**PERMIT SITE PLAN
BELVEDERE ESTATES**

LOT 11

RE: Waiver Approval
3655 Paupers Folly Lane
West Friendship, MD 21794

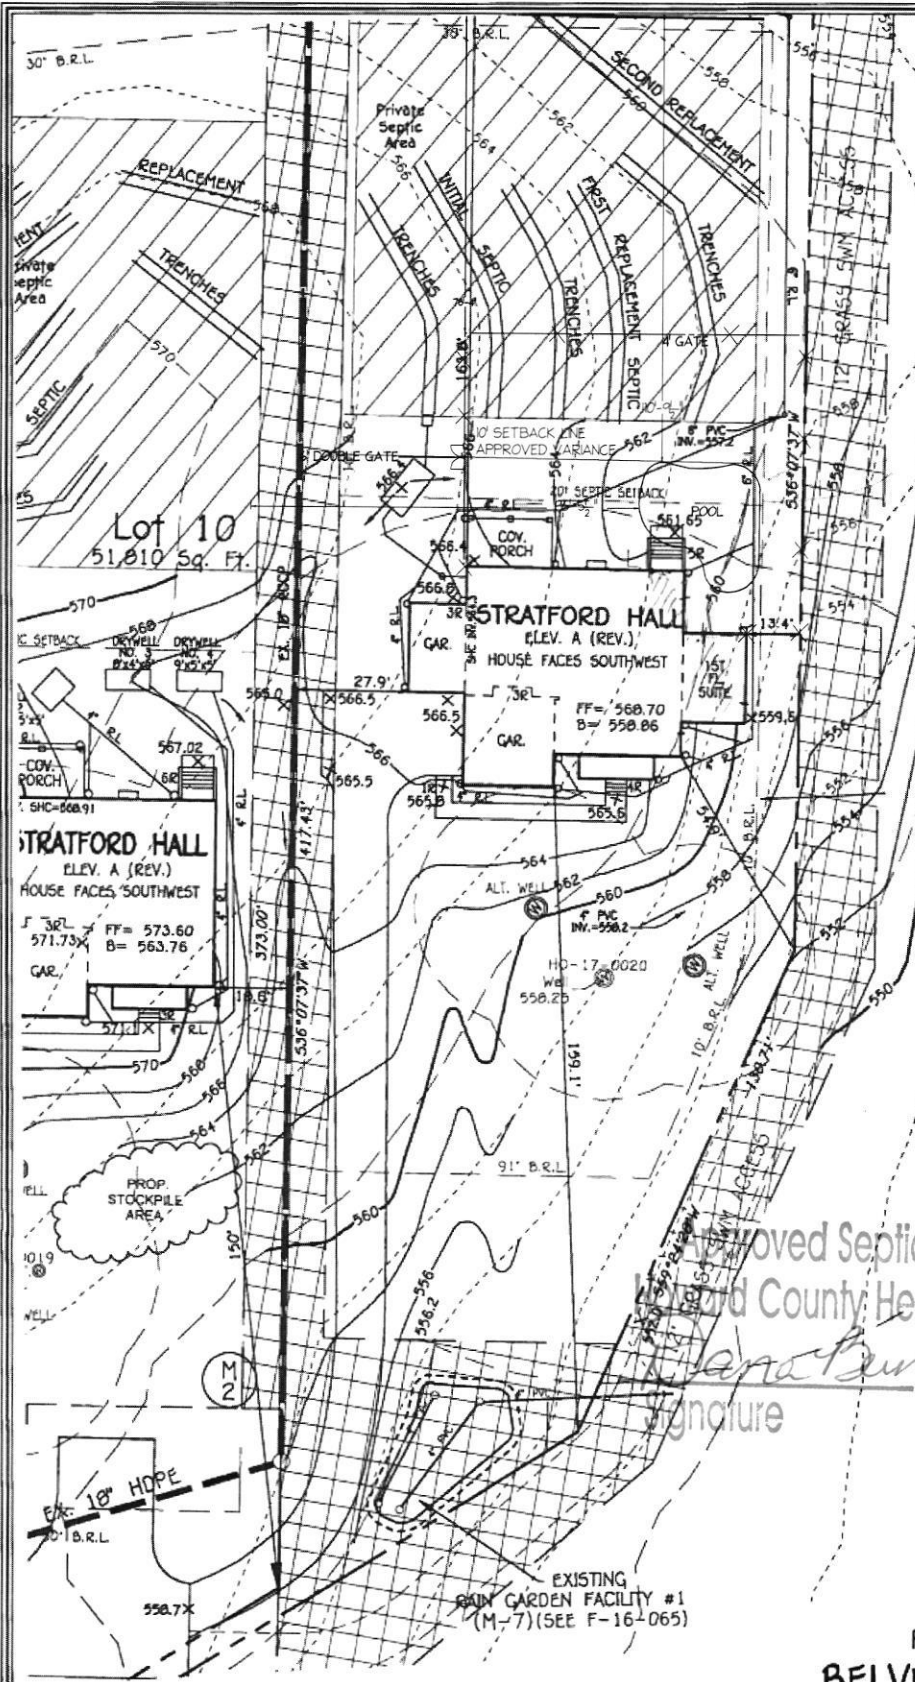
This letter is being issued in response to your waiver request dated September 8, 2021. Your request for a waiver of the Howard County Code twenty (20) setback for an irregular shaped pool to the existing on-site sewage disposal system area has been **approved**. The approximately five hundred (500) square foot pool has been approved ten (10) feet from the existing on-site sewage disposal area.

Be advised that a condition of this waiver requires temporary fencing to be installed five (5) feet from the existing tank, existing trenches and the sewage disposal area to prevent any vehicle or construction equipment traffic in that area during the construction of the pool. The temporary fencing must be installed prior to building permit approval.

Any deviations from the proposed work illustrated on the site plan submitted with the waiver request will be subject to further review by this department.
